RE: Major Thoroughfare Plan modifications to Unnamed Major Thoroughfare and Anserra Trail in the Houston Extraterritorial Jurisdiction

Re: Major Thoroughfare Plan Amendment Request

## Major Thoroughfare Plan Revision

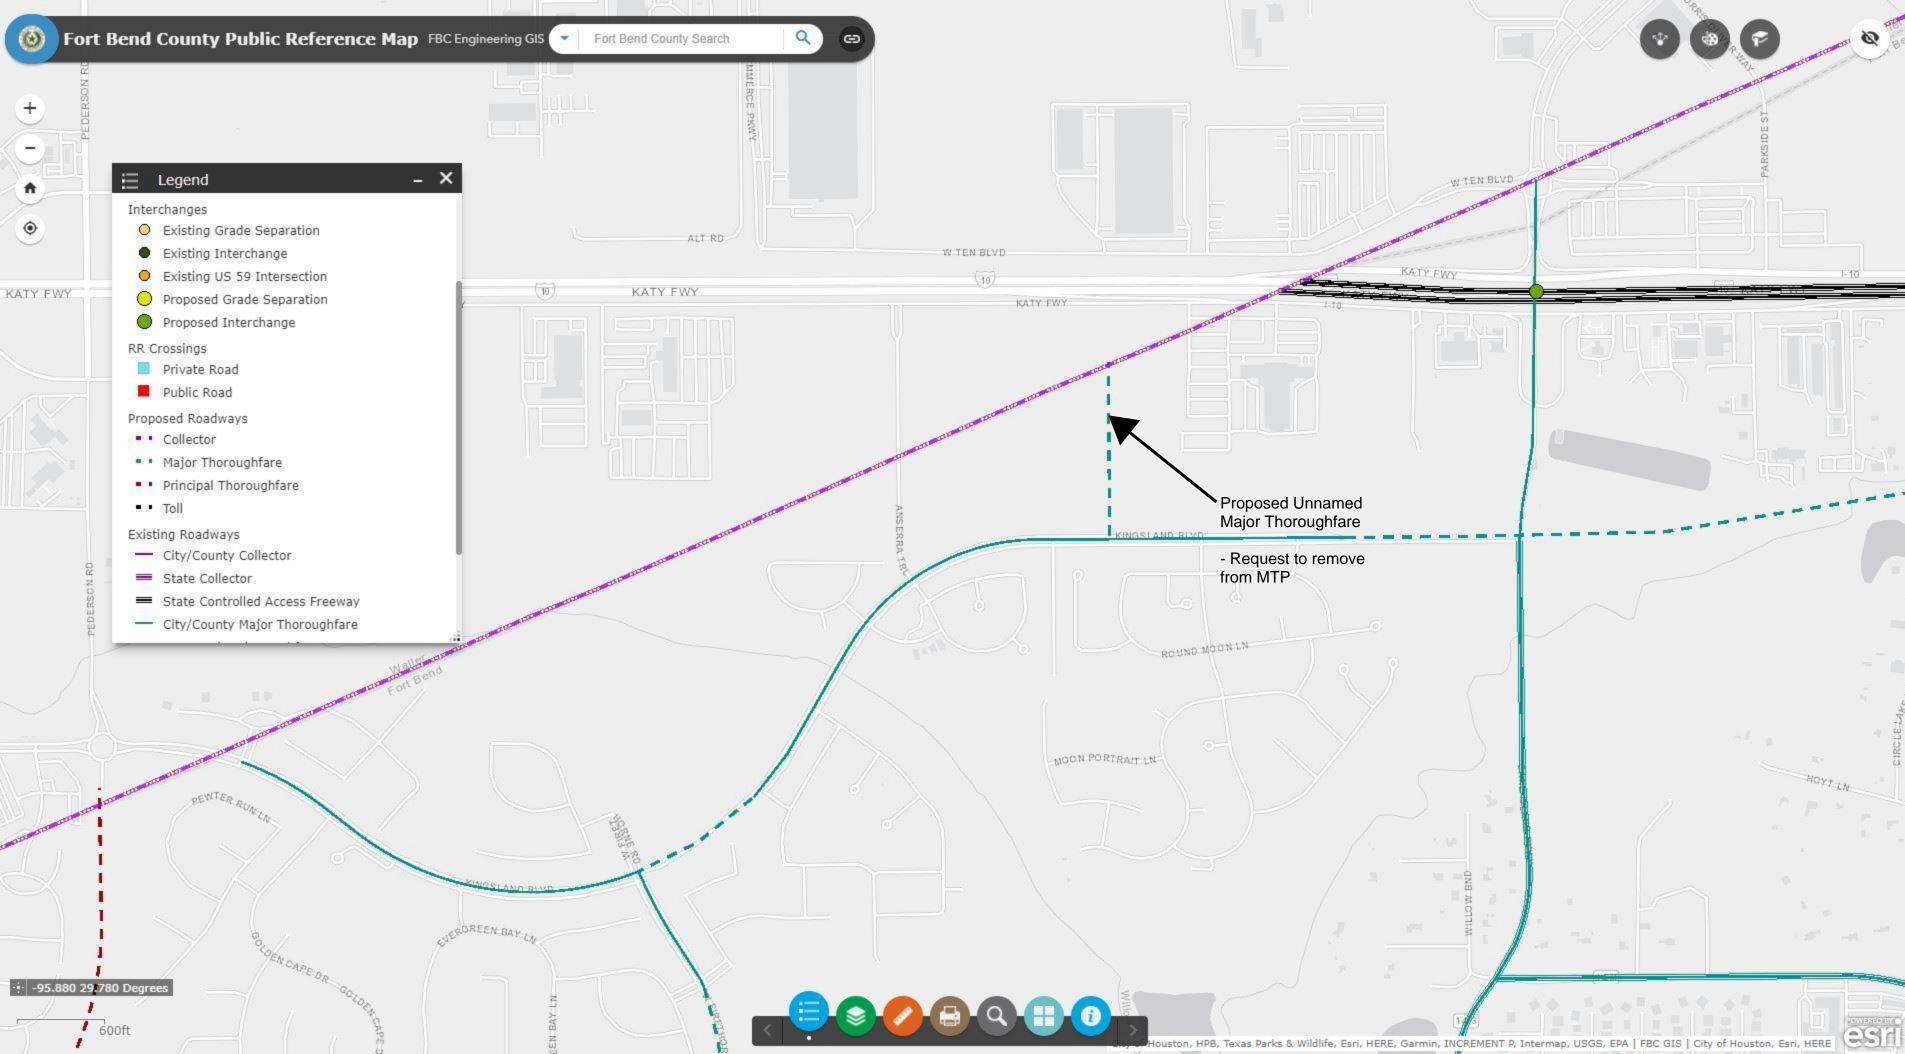
We would like to respectfully request an amendment to the Fort Bend County Major Thoroughfare Plan (MTP) to remove the proposed unnamed major thoroughfare from the plan identified in Exhibit "A". The proposed thoroughfare is located east of Anserra Trail (major collector), west of Cane Island Parkway (Major Thoroughfare), and is proposed to run in a north-south direction between designated major thoroughfares I-10 and Kingsland Blvd within the City of Houston ETJ, Fort Bend County limits.

The current proposed major thoroughfare intends to subdivide the future development tract, Park at Anserra, that will consist of industrial, non-residential uses. This development tract will have access to I-10 frontage road and Anserra Trail, with internal circulation via non-exclusive reciprocal access easements.

Introducing another public street connection in this location would create an undesirable traffic condition where there are three major roadways intersecting with I-10 within 3/4th's of a mile. Additionally, the proposed thoroughfare is planned to intersect I-10 at the gore point of the frontage road and off-ramp, creating another potential traffic hazard.

- **Unnamed Major Thoroughfare** remove the proposed Major Thoroughfare between Kingsland Boulevard and the Fort Bend County line
- Anserra Trail upgrade to a Collector between Kingsland Boulevard and the Fort Bend County line
